From: Scala, Mary Joy
Sent: Thursday, January 22, 2015 1:38 PM
To: 'rilly69@earthlink.net'
Cc: 'Megan Long'
Subject: BAR Action - Jan 20, 2015 - 617 Park Street

Certificate of Appropriateness Application

BAR 15-01-05
617 Park Street
Tax Parcel 520186000
Chris and Megan Long, Owners/Rachel M. Lilly, Applicant
Adjust approved retaining wall and fence; add new fence

**CITY OF CHARLOTTESVILLE
BOARD OF ARCHITECTURAL REVIEW
STAFF REPORT
January 20, 2015**

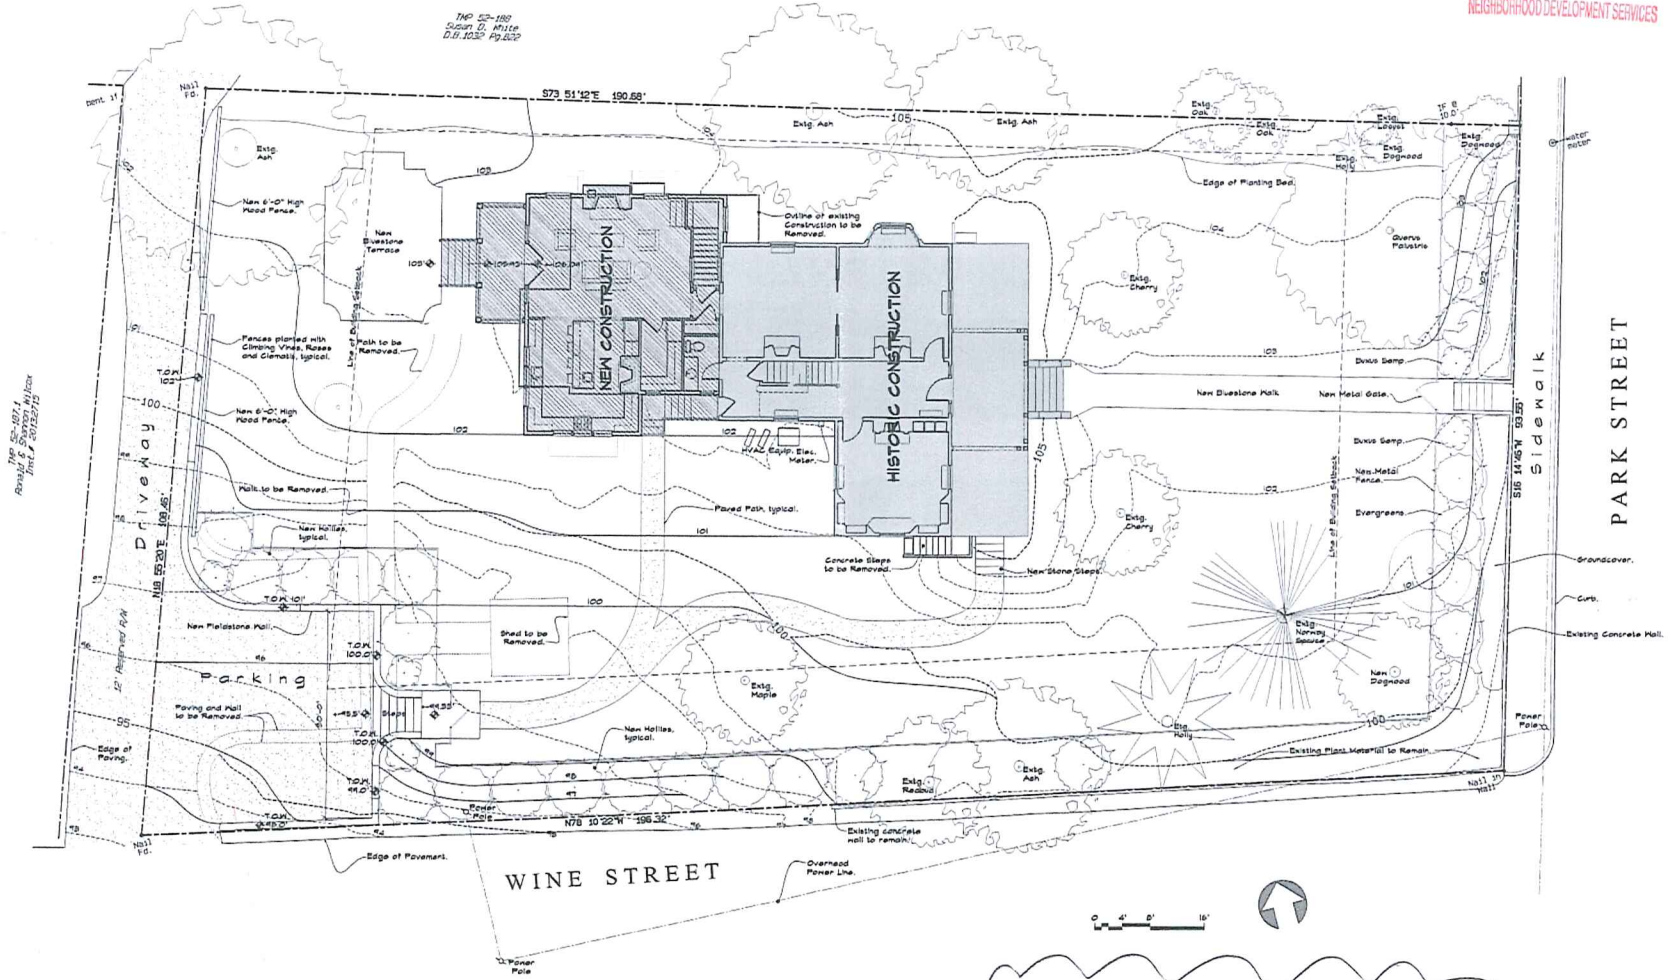
Staff attached a copy of the previously approved site plan. The applicant's requests seem reasonable and appropriate.

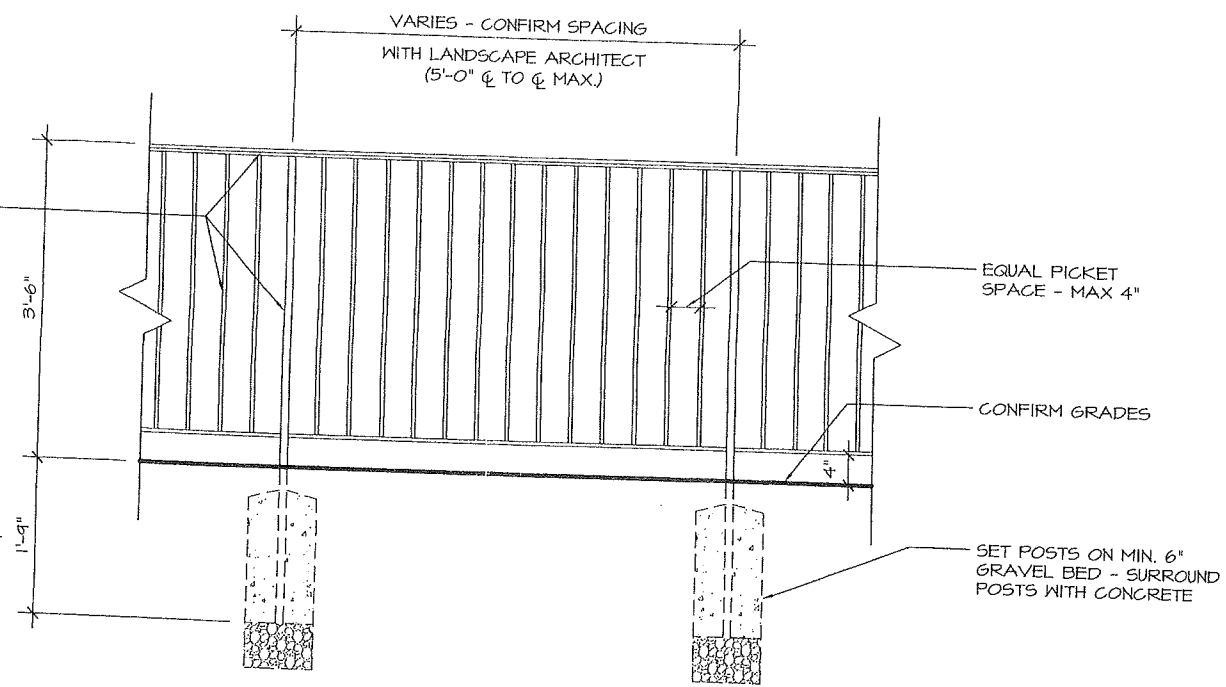
1. The Longs would like to erect (continue) the 6 ft. high board fence from the northwest corner of the property to a location opposite the northeast front corner of the house. (See site plan color yellow.) From this point they would like to erect a 3'-6" high wrought-iron fence which would join up with the already approved fence running parallel to Park and Wine Streets. (See site plan color orange).

Both of these proposed fences running east-west (2 ft. south of the north property line) would replace an existing wire fence.

Site Plan
Scale: 1/8"=1'-0"

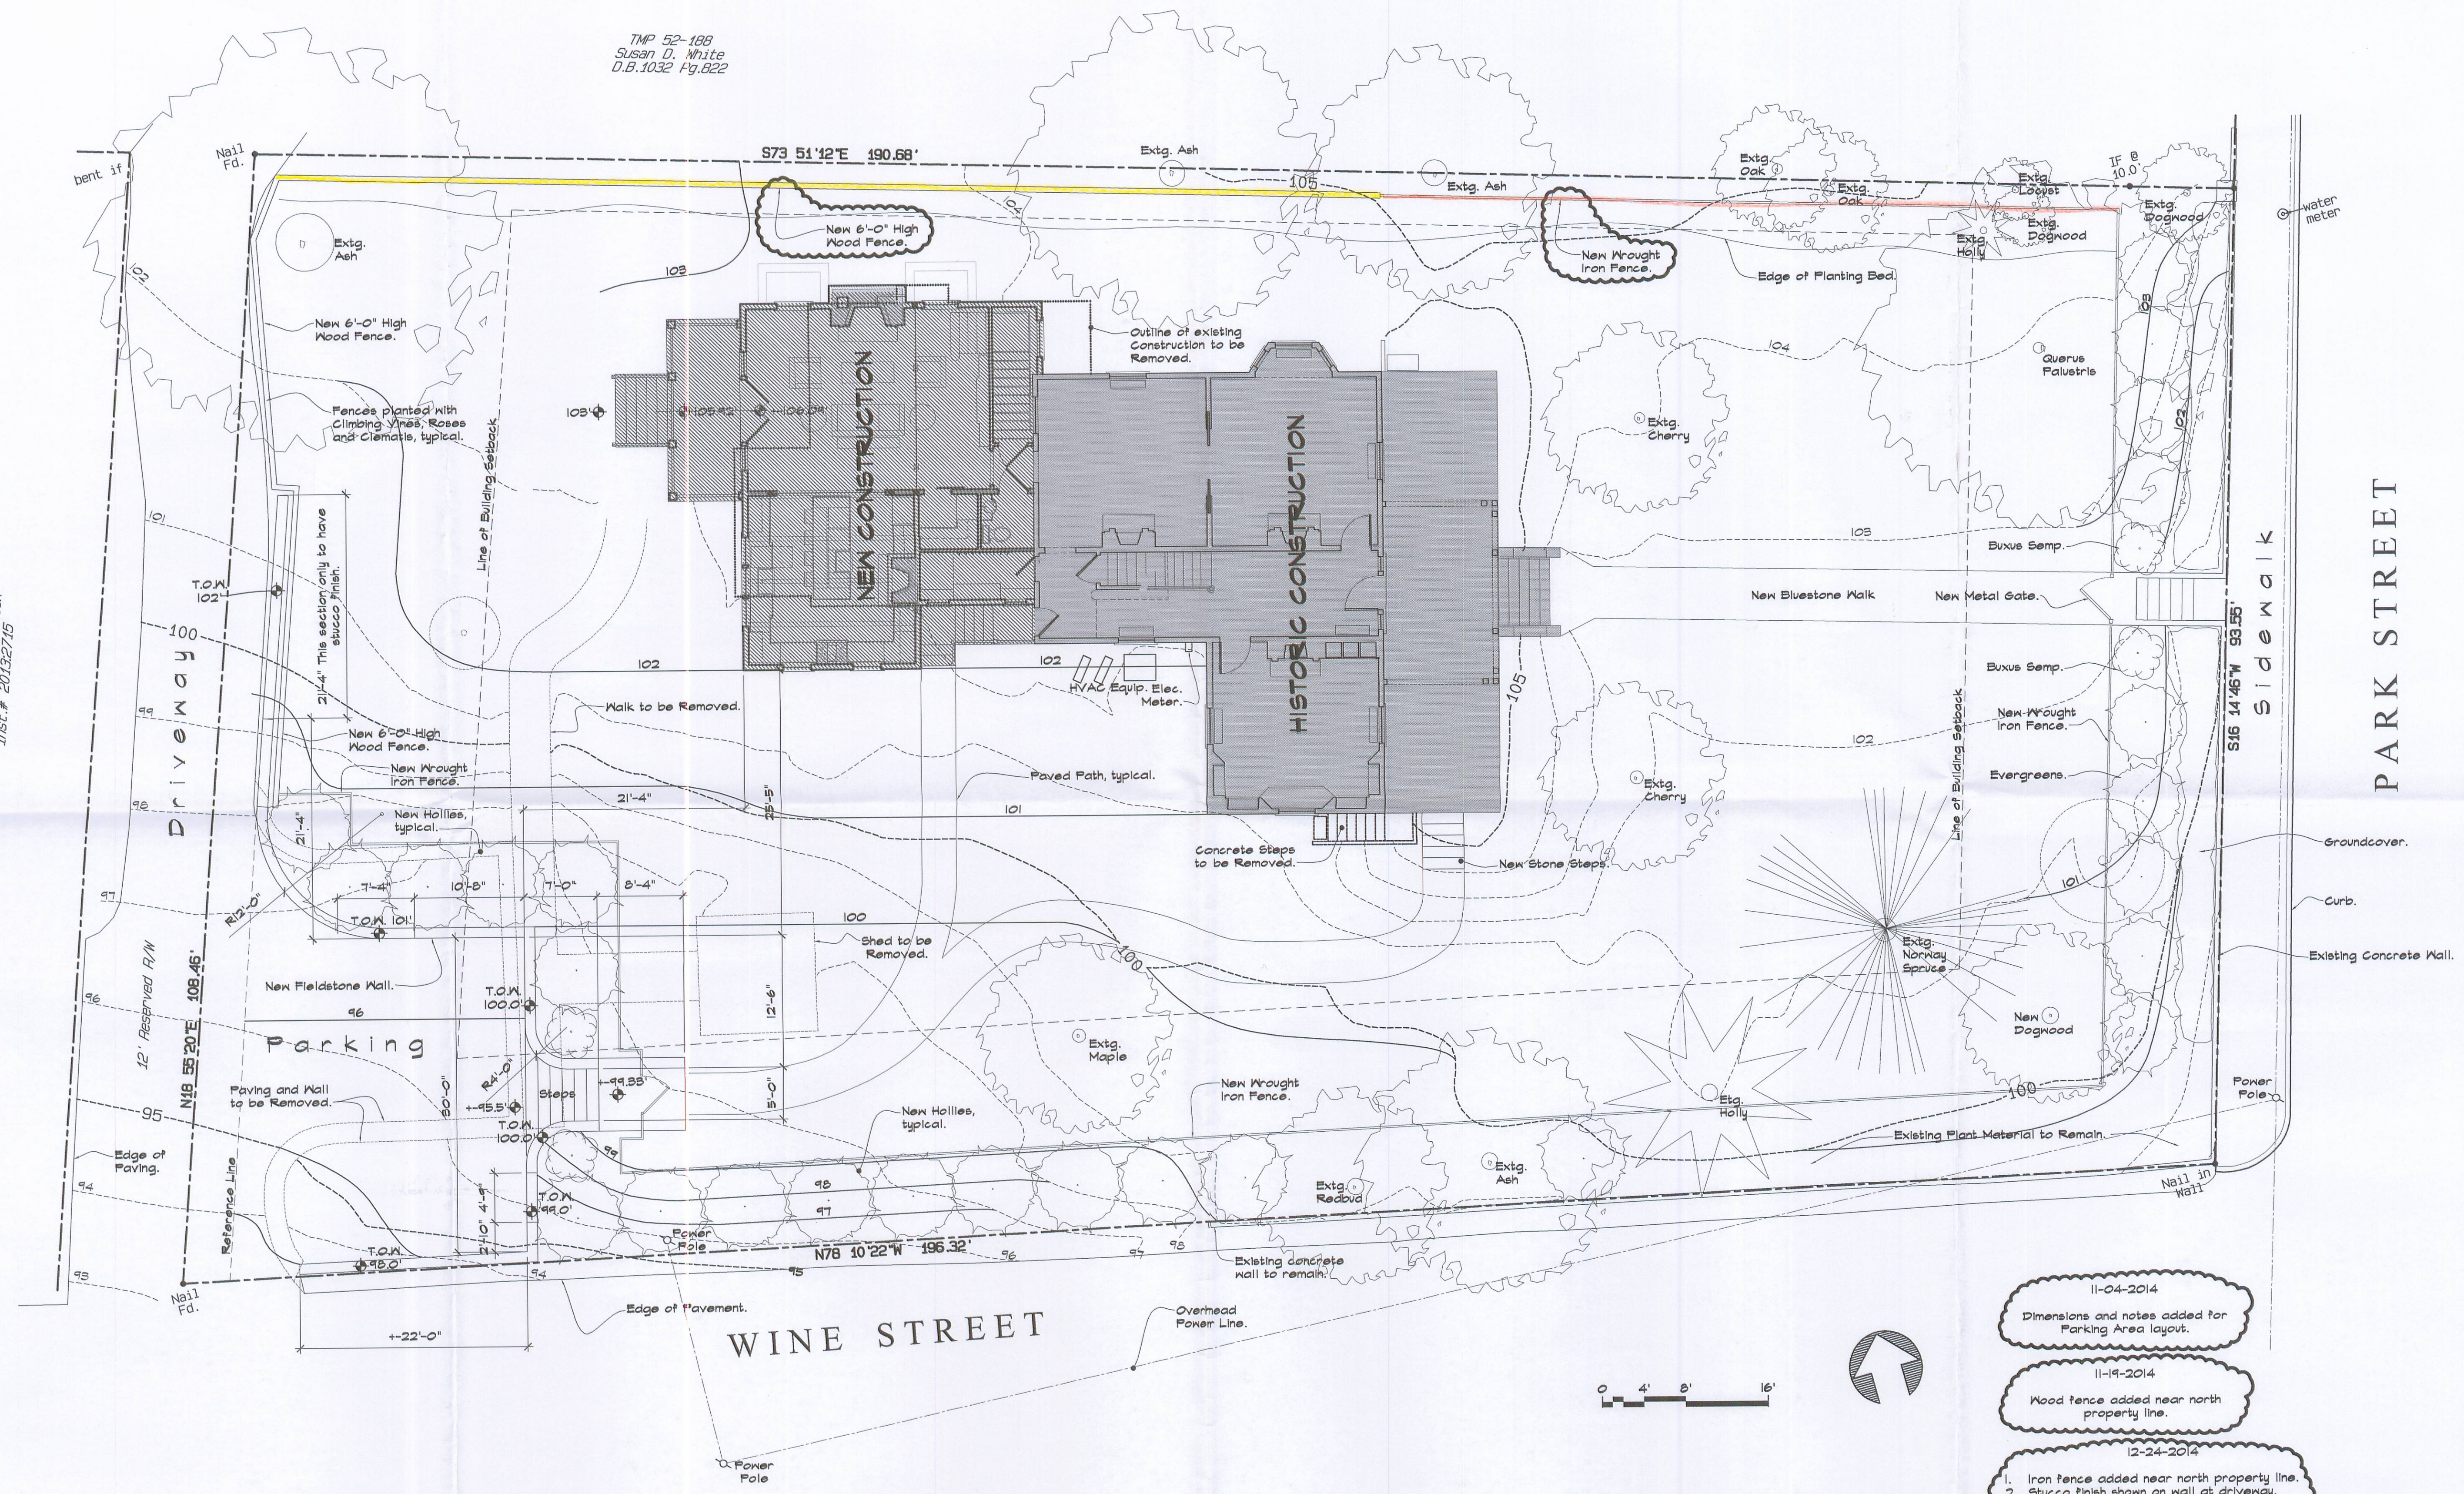
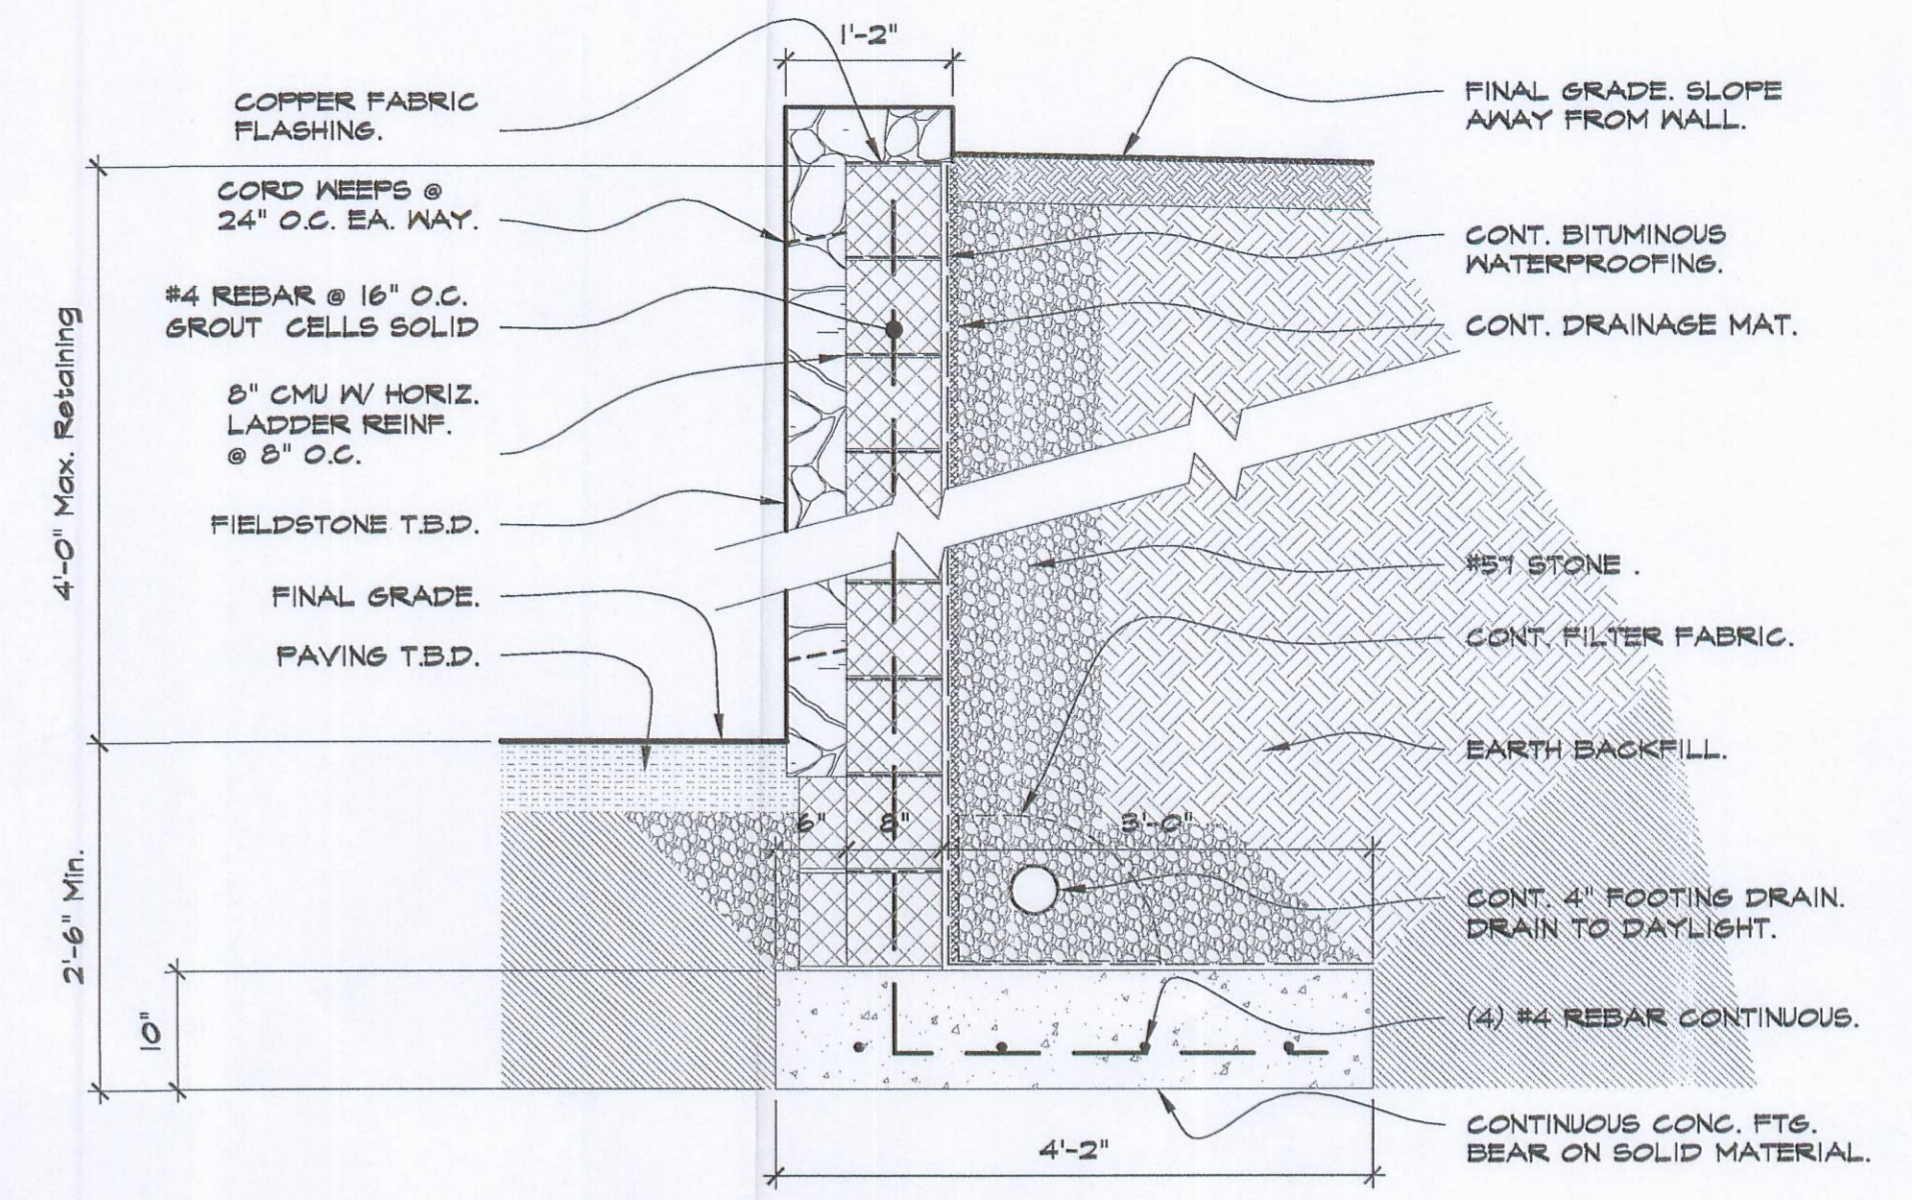
- 11-04-2014
Dimensions and notes added for Parking Area layout.
- 11-19-2014
Wood fence added near north property line.
- 12-24-2014
1. Iron fence added near north property line.
2. Stucco finish shown on wall at driveway.
3. Wall moved away from shared driveway.
4. Fence line adjusted @ shared driveway.
5. Terrace removed @ west side of house.

2 Site Retaining Wall Section - Stucco
 S1.1 3/4" = 1'-0"

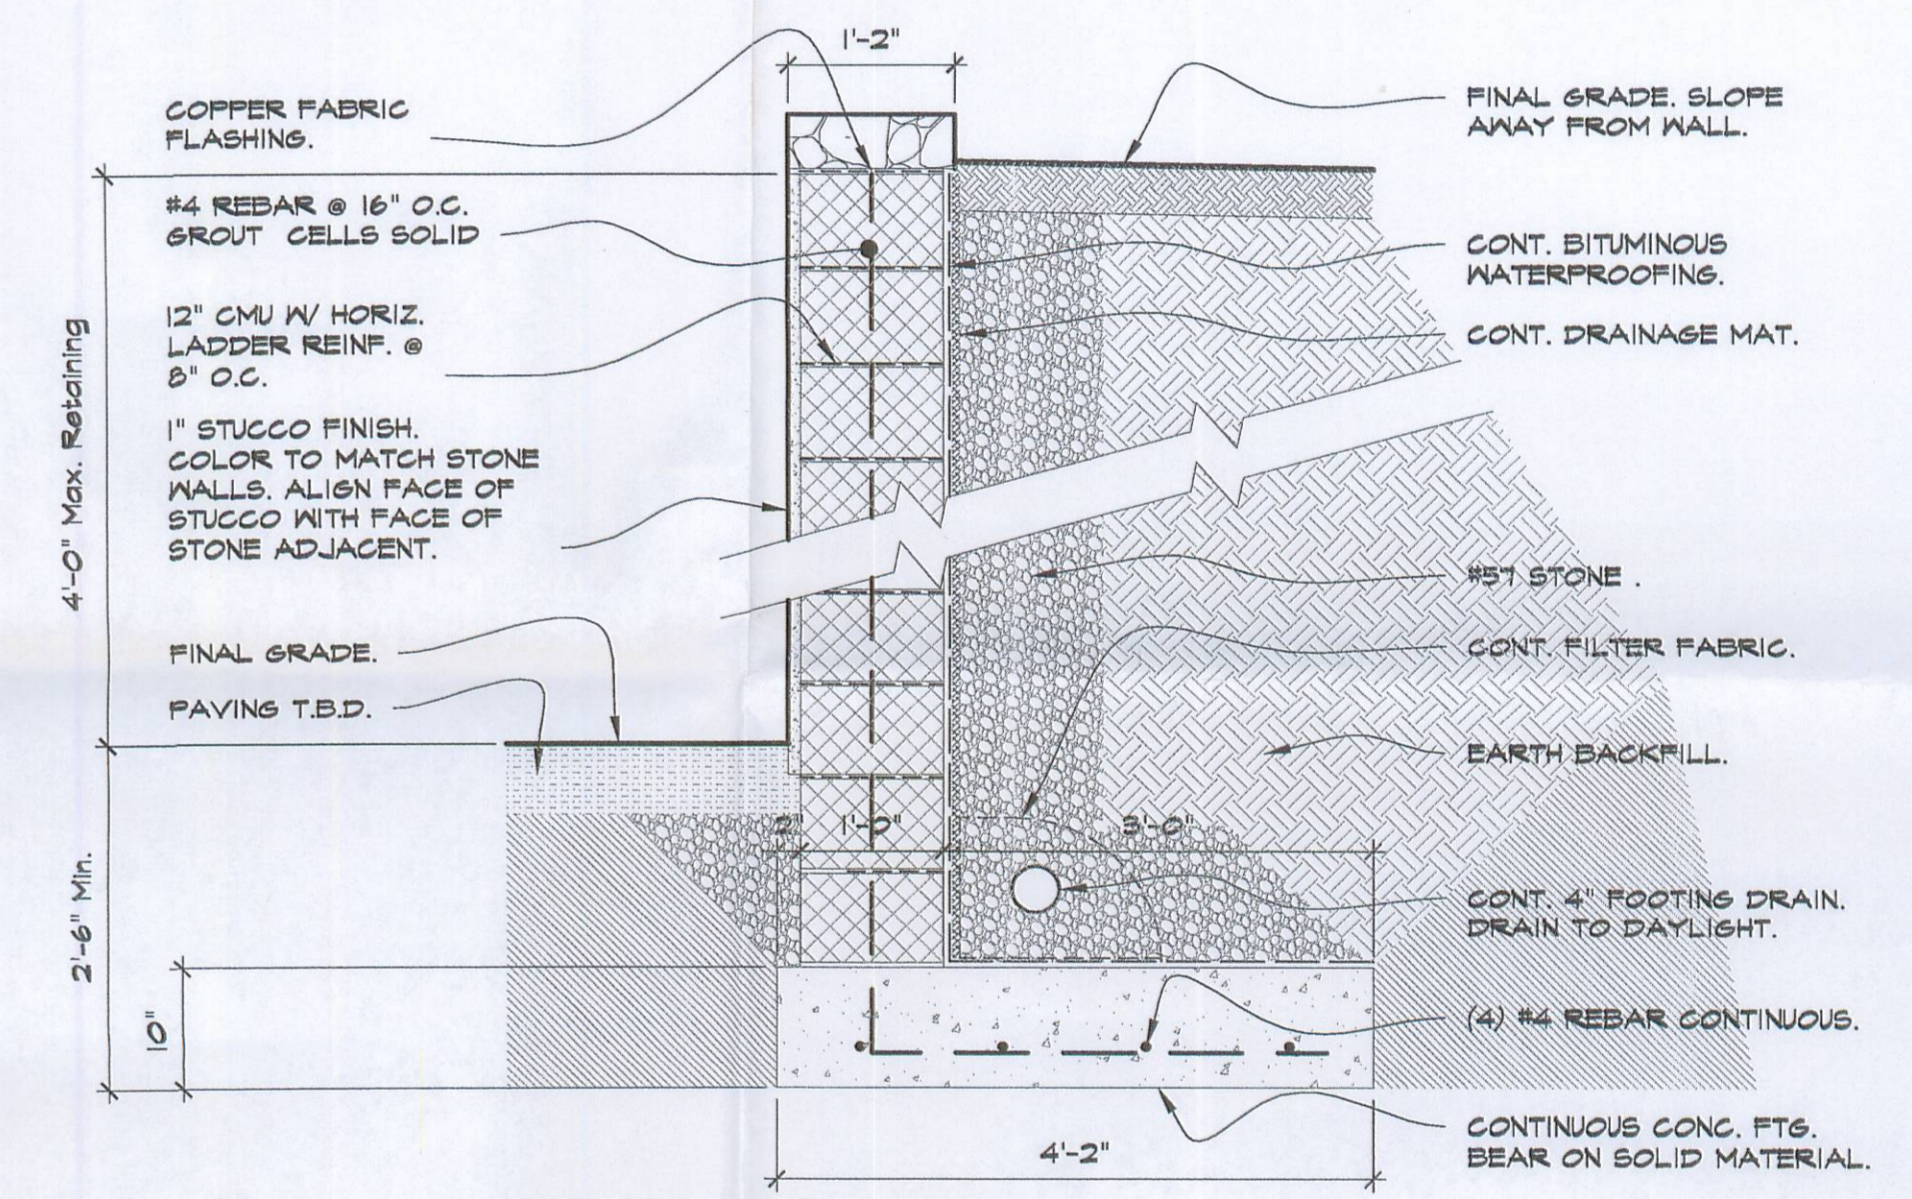
Additional changes to the approved plan include: (2) a request to reposition a portion of the wood fence to allow less impact on the roots of an existing Oak tree; and (3) a request to apply stucco finish instead of stone to approximately 21 feet of the wall. The wall would retain a continuous stone coping.
